Access Compliance Report

Public Rights-of-Way

(Curb Ramps)

Intersection ID: 10037210	Main Street: SANDY_ROCK_PL	Cross Street: N/A	Location: E
ADA ID: 9C438F23F4EA	Ramp Type: Perp	Initial Pass/Fail: Fail	Overall Compliance: No
Severity Score: 13.75			
Codes/Mitigation Info/Possible Solution		Field Measurements/Component Compliance

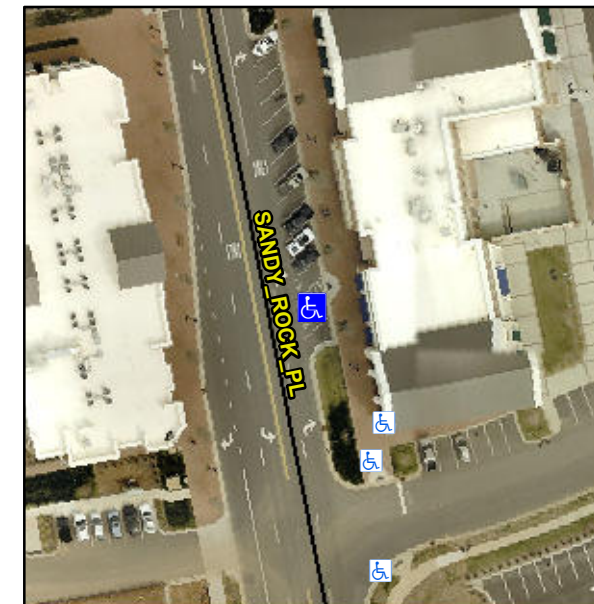
R304.2.2, R304.5.3

Compliance	Description	Data	Compliance	Description	Data
N/A	Ramp Length (in)	76.5	No	Ramp Slope (%)	8.8
Yes	Ramp Width (in)	48.0	No	Ramp XSlope (%)	2.4
N/A	Flare Type LT	N/A	N/A	Flare Type RT	N/A
N/A	Flare Slope LT (%)	N/A	N/A	Flare Slope RT (%)	N/A
N/A	Flare Traversable LT?	N/A	N/A	Flare Traversable RT?	N/A
N/A	Landing Length (in)	N/A	N/A	DWS Provided?	N/A
N/A	Landing Width (in)	N/A	N/A	DWS Contrast?	N/A
N/A	Landing Slope (%)	N/A	N/A	DWS Length (in)	N/A
N/A	Landing X Slope (%)	N/A	N/A	DWS Full Width?	N/A
N/A	Landing Curb? (Y/N)	N/A	N/A	DWS Offset (in)	N/A
N/A	Shared Landing?	N/A			
N/A	Gutter Ponding?	N/A	N/A	Gutter Slope (%)	N/A
N/A	Gutter Lip Ht (in)	N/A	N/A	Gutter X Slope (%)	N/A
N/A	Painted X Walk1?	No	N/A	Painted X Walk2?	N/A
	X Walk 1 Direction	To W		X Walk 2 Direction	N/A
N/A	X Walk 1 Width (in)	N/A	N/A	X Walk 2 Width (in)	N/A
	X Walk 1 Slope (%)	2.0		X Walk 2 Slope (%)	N/A
	X Walk 1 X Slope (%)	1.7		X Walk 2 X Slope (%)	N/A

Remove & Replace Entire Ramp.
